PUBLIC INTEREST REVIEW FOR GROUND WATER APPLICATIONS

SUBJECT: Application G- 16489 Supersedes review of N/A
Date of Review(s)

A. GENERAL INFORMATION: Applicant's Name: City of Gearhart County: Clatsop

Transient Stream Depletion - Linear

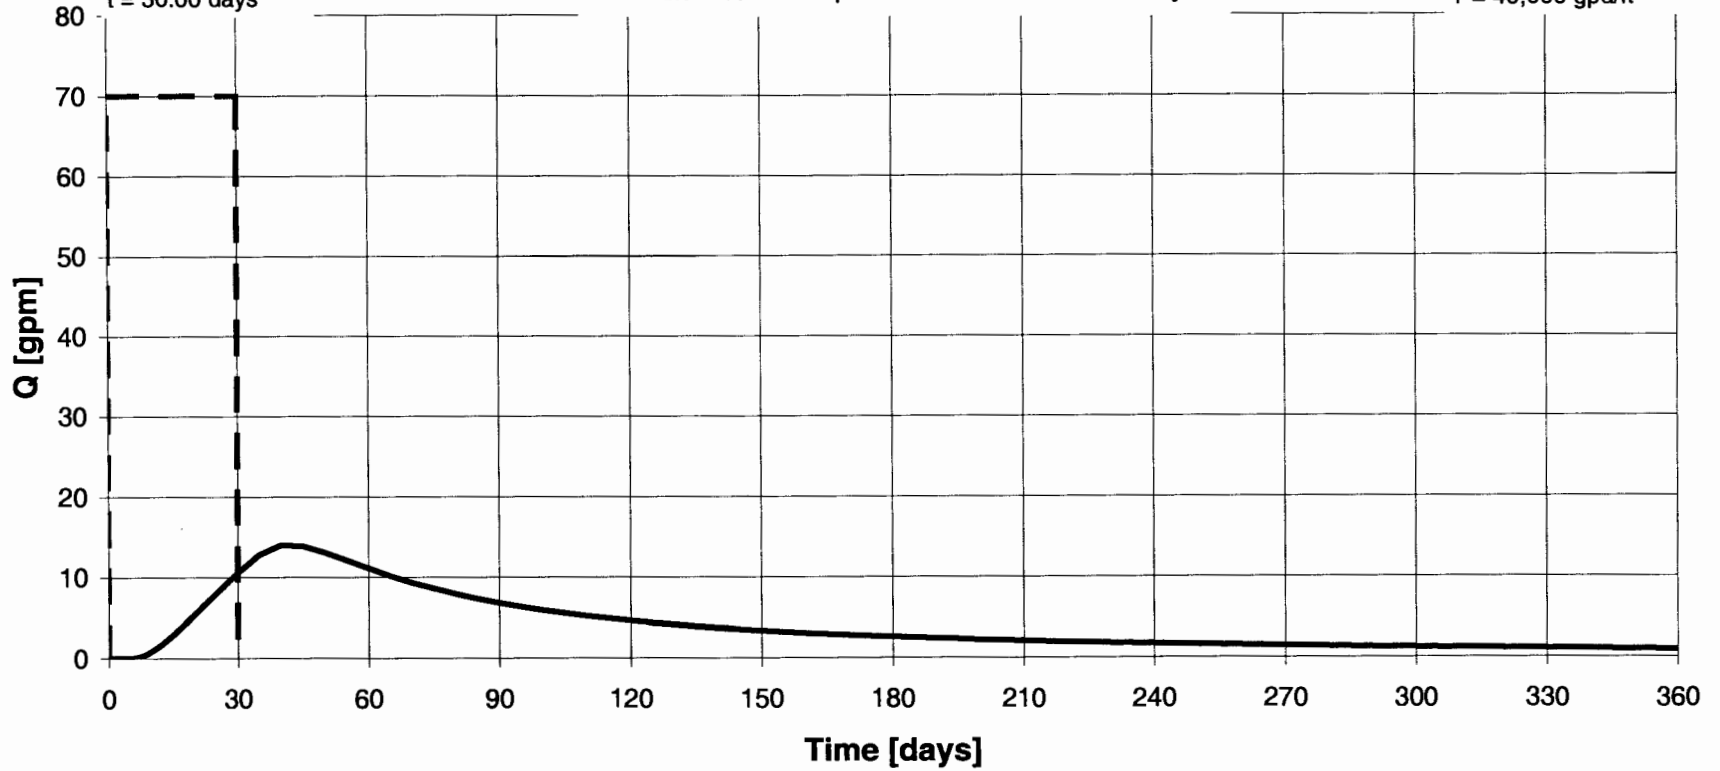
To be as conservative as possible, the simple analytical model of Jenkins was used to evaluate the impact of the closest proposed well (#14) to the closest fresh water stream (Neacoxie Creek). The Jenkins model assumes no streambed clogging, and a stream that fully penetrates into the aquifer. A low aquifer storage of 0.15, and a high transmissivity of 40,000 gpd/ft, were chosen. After 30 days of pumping the impact was estimated at 15%, less than the 25% Div. 9 criteria. Again, because of the presence of the nearer boundary to the west, the real impact would be less than this 15%. The remaining wells and streams will each have a lower percent impact due to the greater distances involved.

Transient Stream Depletion = 15% at t = 30.00 days
